## ELECTRIC STOP CLOCK

### KS-14235

## REQUIREMENTS AND ADJUSTING PROCEDURES

1.001 This addendum supplements Section 030-115-701, Issue 2.

Fig. 9—KS-14235 L2 Stop Clock and KS-14249 L2 Switch

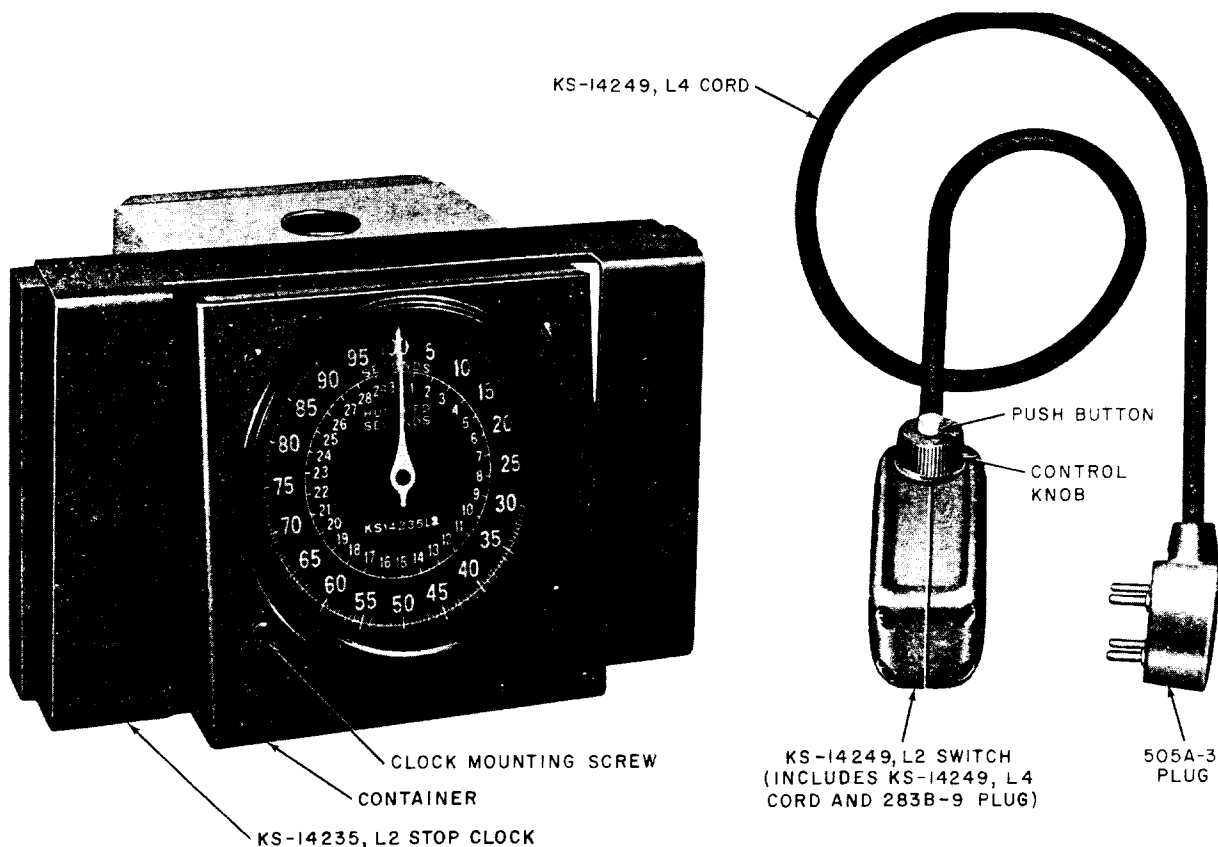
1.002 This addendum is issued to add a paragraph covering the relationships of the different list numbers of KS-14235 clocks and KS-14249 switches, to add a figure illustrating the KS-14235 L2 clock and KS-14249 L2 switch, and to add a figure illustrating plug connections for the 505A-3 plug.

(b) Fig. 9—added

1.09 In the case of the KS-14235 L1 and L3 clocks, the KS-14249 or KS-14249 L3 switch is part of the clock. In the case of the KS-14235 L2 clock, however, the KS-14249 L2 switch, although used with the clock, is not furnished with it. The KS-14249 L4 cord shown in Fig. 9 is part of the KS-14249 L2 switch. Fig. 10 shows the plug connections.

Fig. 10— 505A-3 Plug Connections

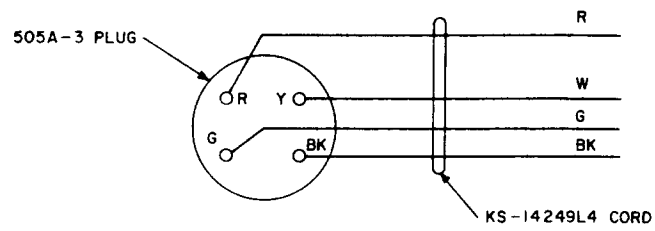
(c) Fig. 10—added
